Identification of Codes and Standards Issues

Report - 0911

19 December 2009

Figure 1.1: Single headers

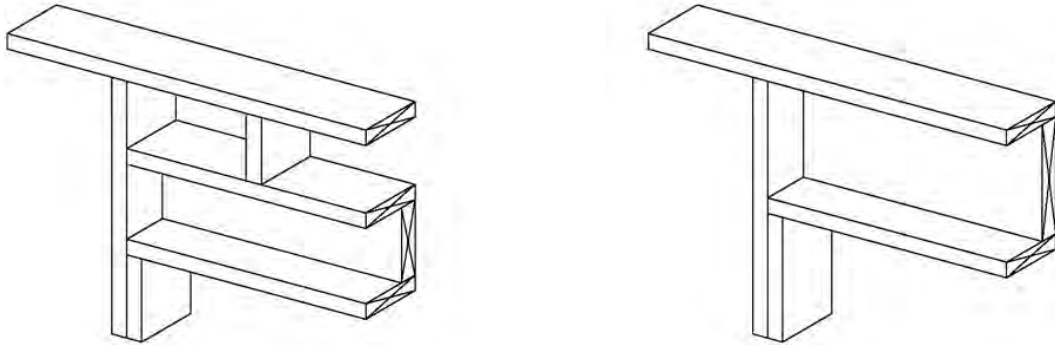
Modification of IRC Section 602.7 - relating to single headers. The documentation for this code change is referenced as "Appendix B.1.4.2_Lstiburek RB 104". This designation refers to the actual modification reference used in the Code Development Hearings that took place in Baltimore, MD, October 24 to November 11, 2009.

This code change affects the design and construction of advanced frame single family residential houses. Almost all advanced frame construction details are already referenced in the IRC - except a provision for single headers. This absence has affected the construction of all advanced frame houses to date.

R602.7.1 Single member headers in exterior bearing walls. Single member headers in exterior bearing walls shall be permitted in accordance with Table R602.7.1. Single headers shall be framed top and bottom with a flat-wise 2x member. To make up the remaining space, cripples should be installed above the header. Alternatively, the header can be sized to fill the space between the wall top plate and a flat-wise 2x member. The header assembly shall bear on a minimum of one jack stud at each end.

This proposal provides a means of implementing advanced, energy-saving wall construction practices for limited conditions where single headers can be used. Thus, insulation can be placed together with the single header to prevent heat loss through headers which otherwise create a thermal short-circuit in exterior walls. The table is evaluated in accordance with the NDS-2005 and ASCE 7-05 building loads. For ease-of-use, the table format is consistent with the principle header tables found in Chapter 5 of the code. The single header practice has been use successfully in thousands of homes since originally developed under the optimal value engineering “OVE” banner by the NAHB and HUD in the 1960’s and more recently under the HUD/PATH and DOE Build America programs.
